STATE OF VERMONT AGENCY OF TRANSPORTATION

PROPOSED IMPROVEMENT BRIDGE PROJECT TOWN OF HARTLAND COUNTY OF WINDSOR

RECORD PLANS	
CONTRACTOR:	KUBRICKY CONSTRUCTION CORP. - WILTON, NY
RESIDENT ENGINEER:	DARYL BASSETT
CONSTRUCTION BEGAN:	JUNE 10, 2014
CONSTRUCTION COMPLETE:	NOVEMBER 5, 2014
RECORD PLANS BY:	DARYL BASSETT & KEVIN KING
I HEREBY CERTIFY THAT ALL THE CONSTRUCTION REQUIRED BY THIS SET OF DRAWINGS HAS BEEN ACCOMPLISHED AS INDICATED HEREIN.	
BY	RESIDENT ENGINEER
DATE	2/22/16
NOTE: Any further information concerning final quantities, amounts or other details relative to this project may be found by contacting Vtrans Records Management.

US ROUTE 5 (MAJOR COLLECTOR), BRIDGE NUMBERS 62A AND 66

**NOTE:**  
 SEE SHEET 25 FOR CURTAIN WALL REINFORCING PLAN

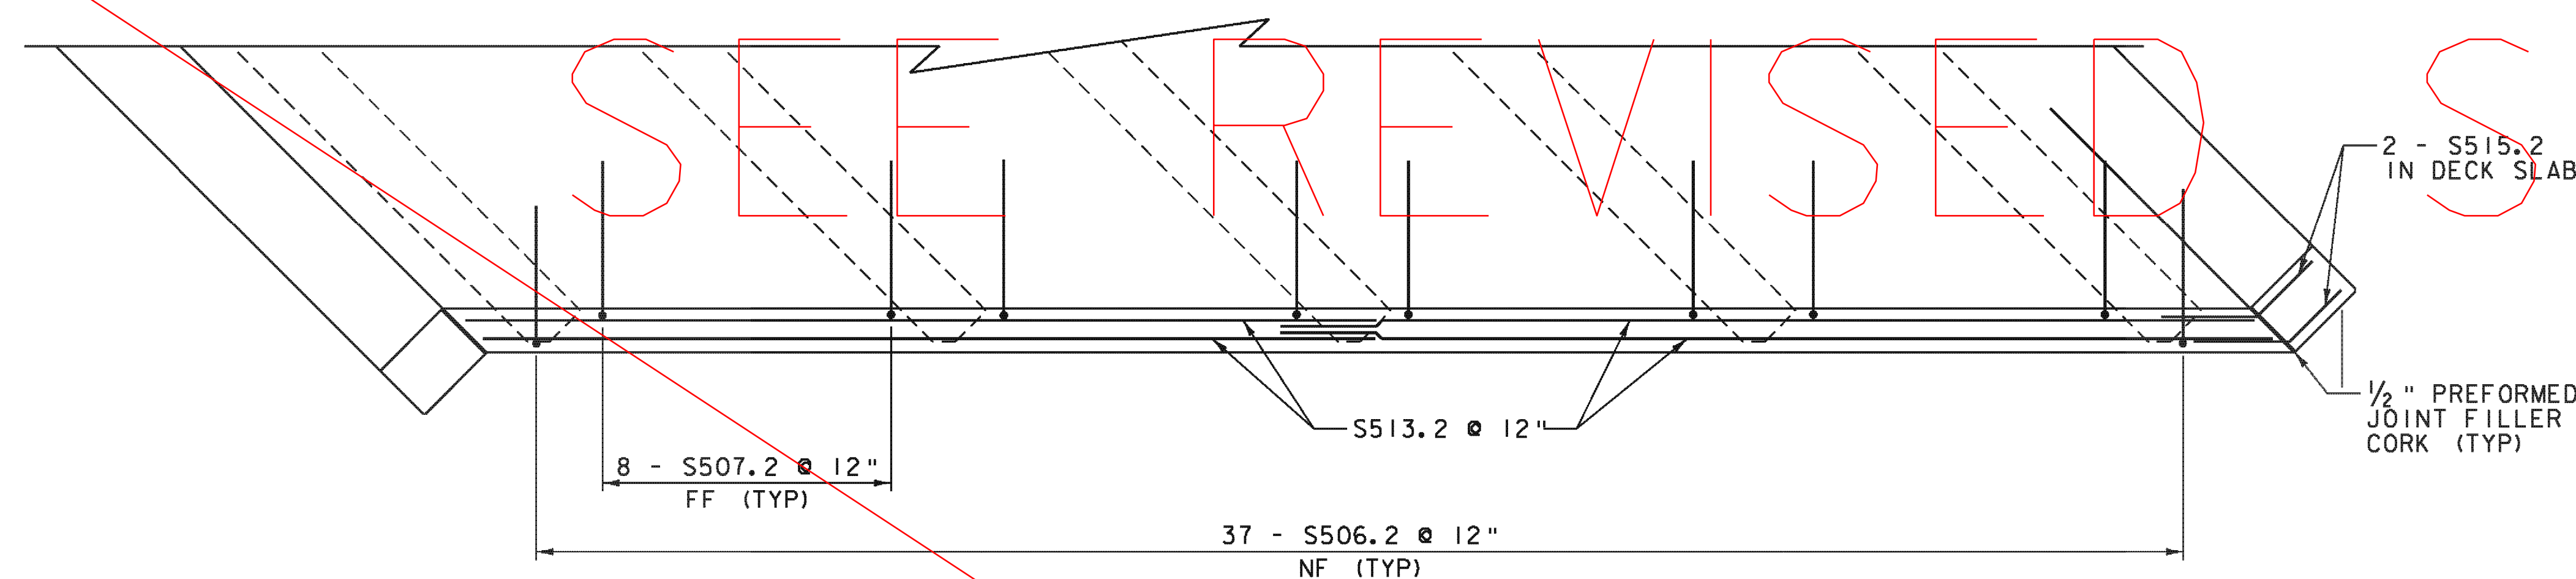
SEE REVISION SHEET

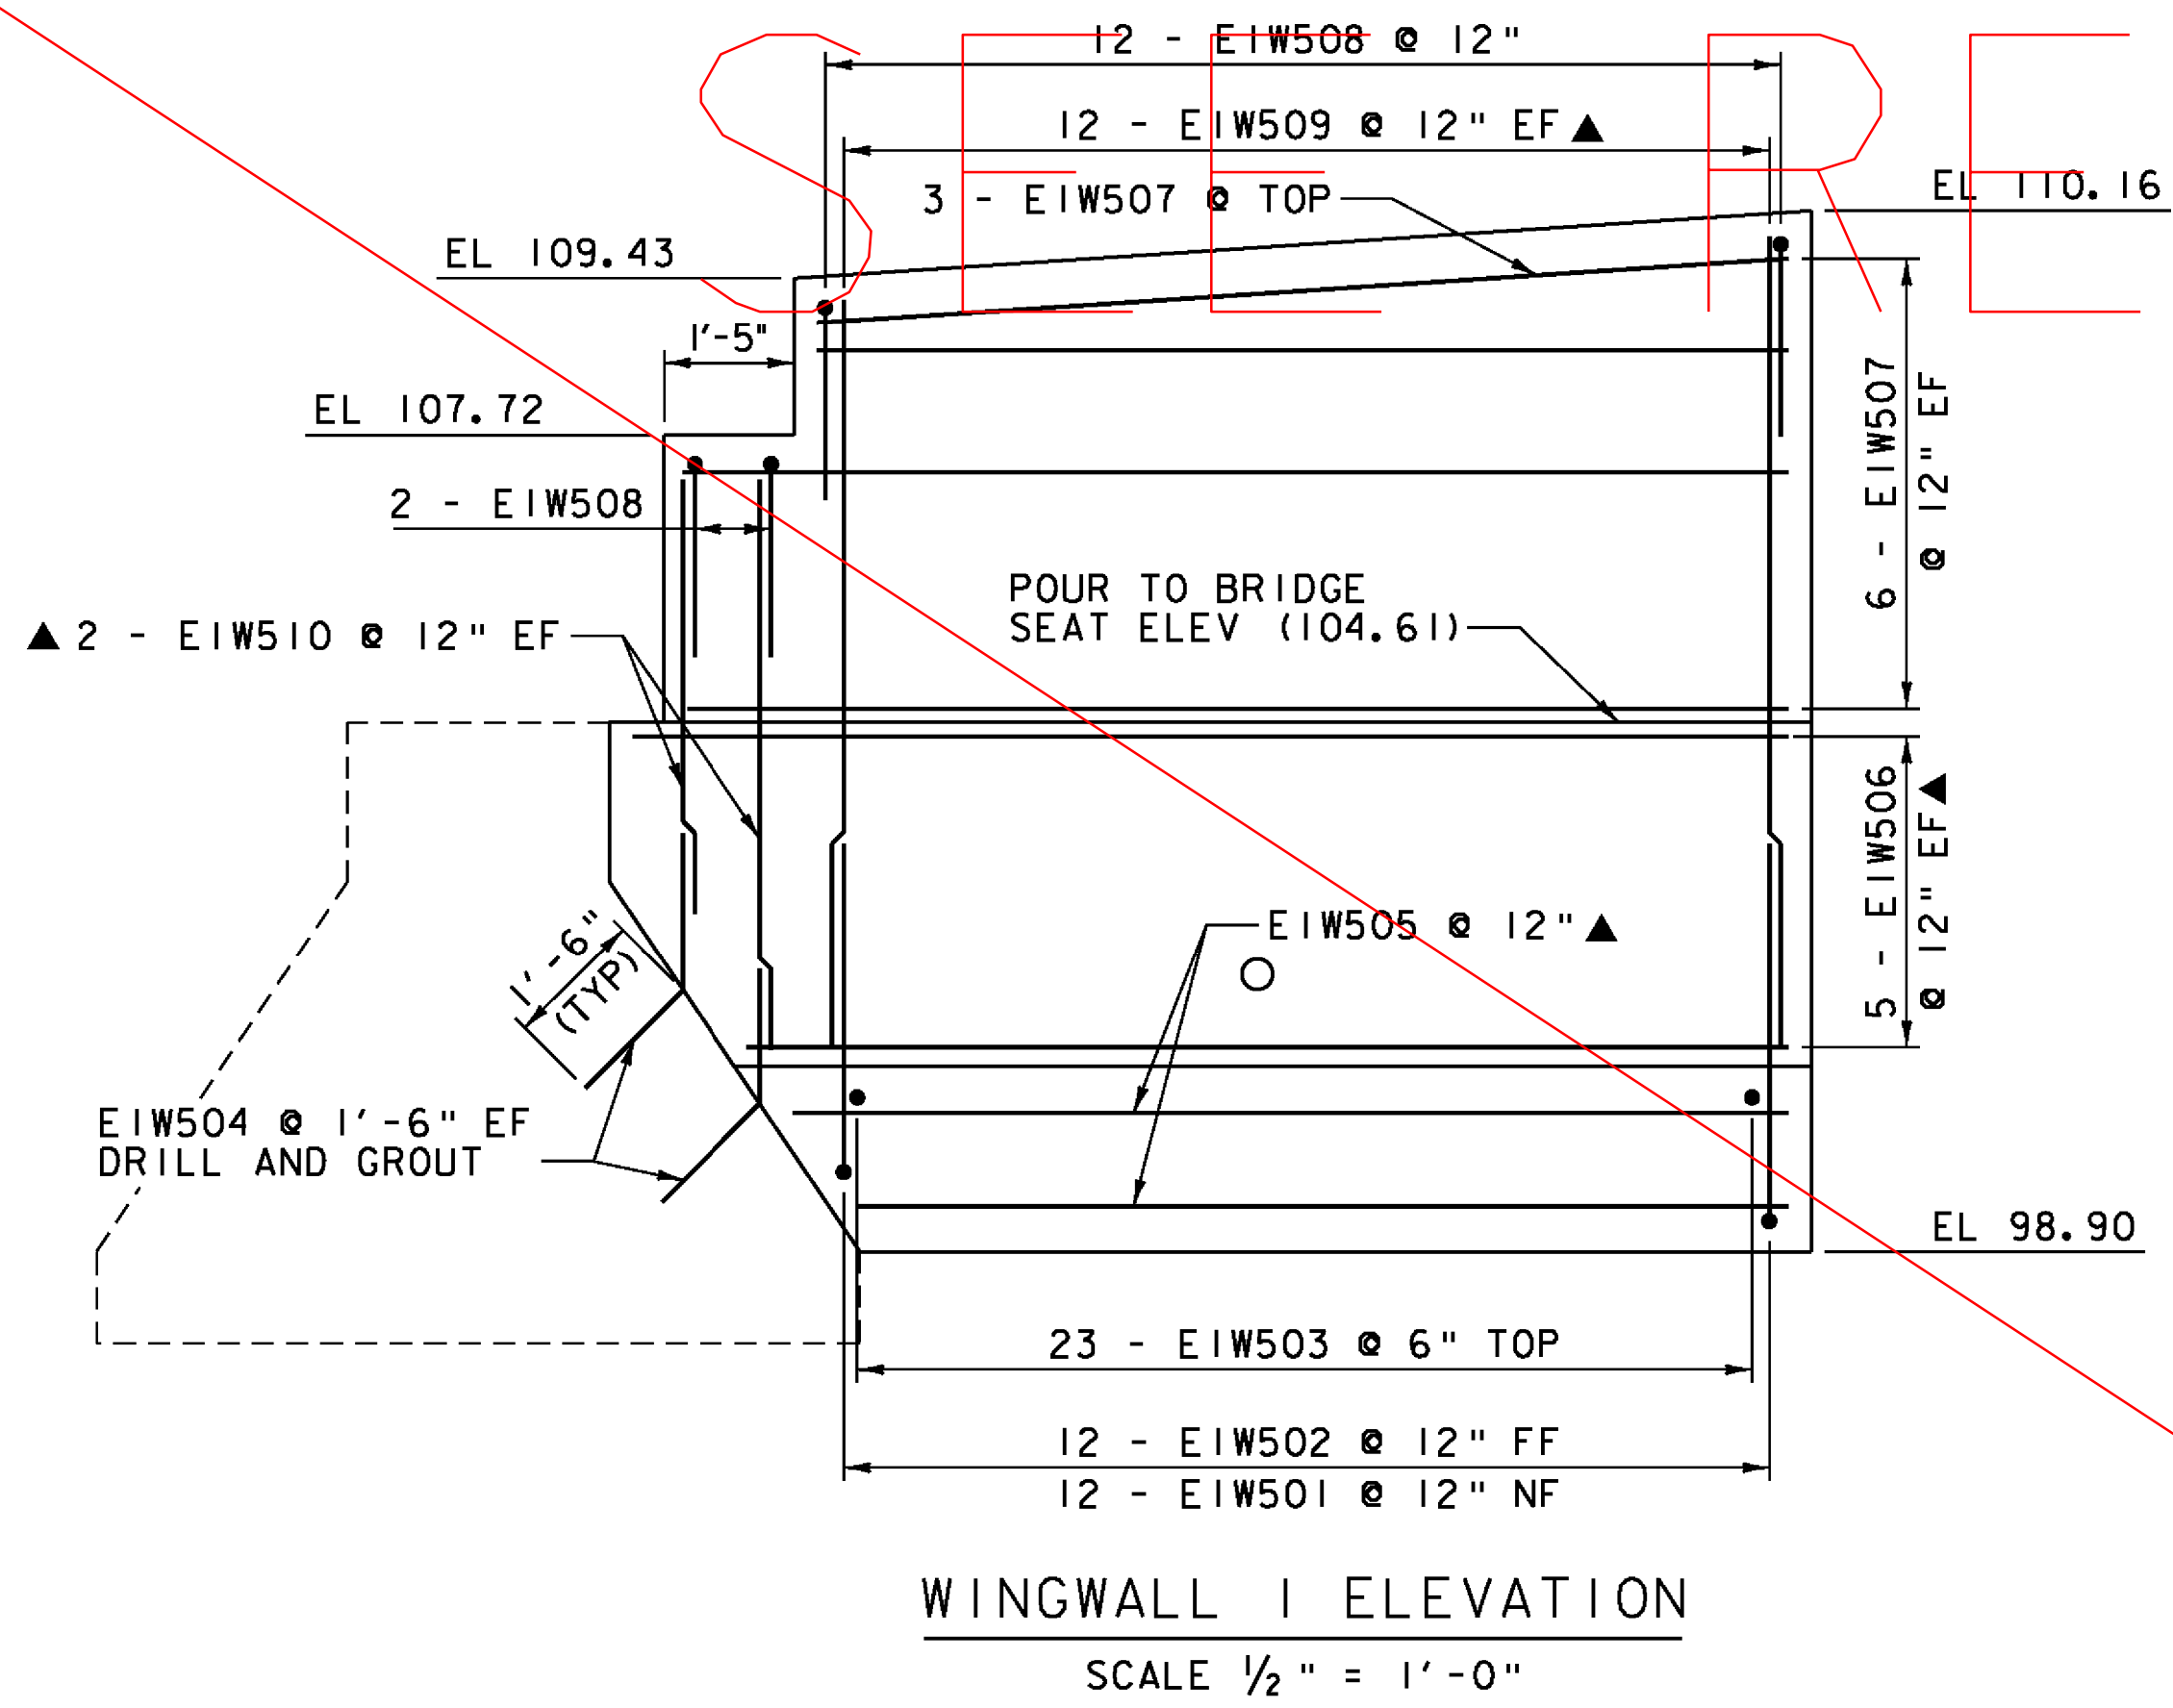
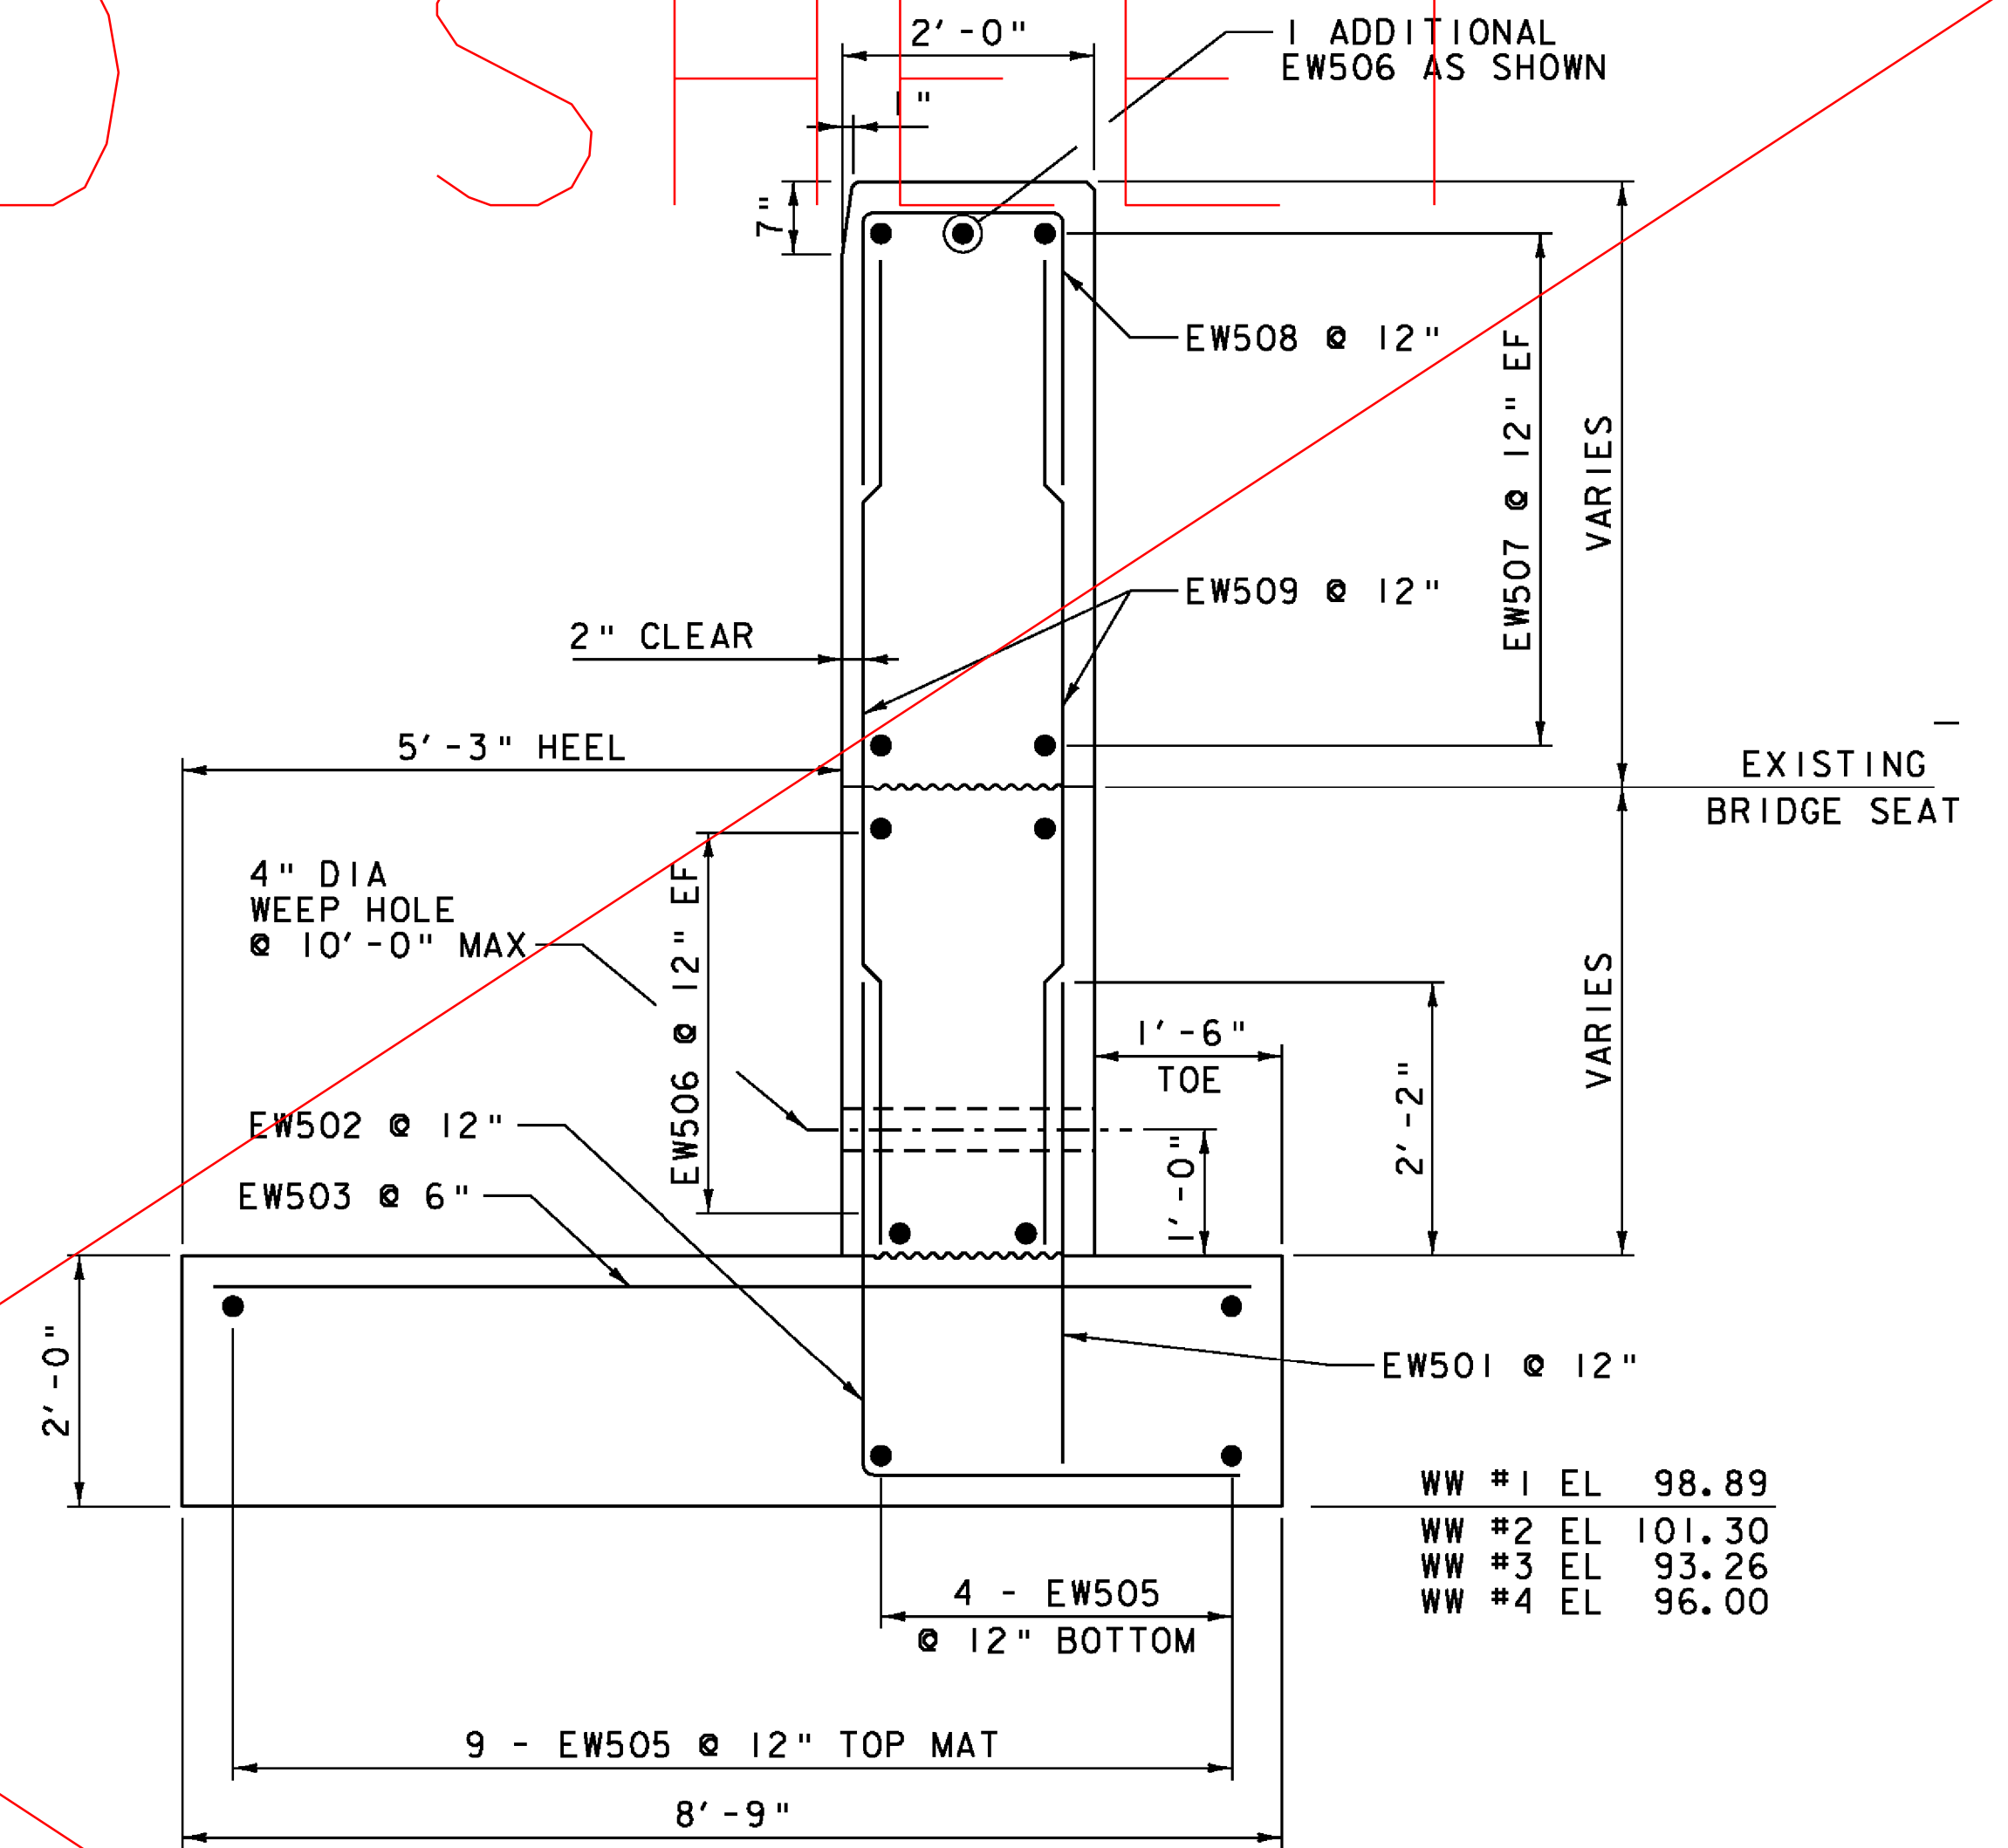
REV.	DESCRIPTION	DATE
△	ADDITIONAL EW508 AT POSTS	3/3/2014
PROJECT NAME: HARTLAND		
PROJECT NUMBER: BHF BPNT(12)		
FILE NAME: z:\c260sub.dgn		PLOT DATE: 3/3/2014
PROJECT LEADER: M.A. COLGAN		DRAWN BY: A.J. GOUDREAU
DESIGNED BY: A.J. GOUDREAU		CHECKED BY: S.G. FARNSWORTH
BR 62A WINGWALL DETAILS (1 OF 2)		SHEET 28 OF 55
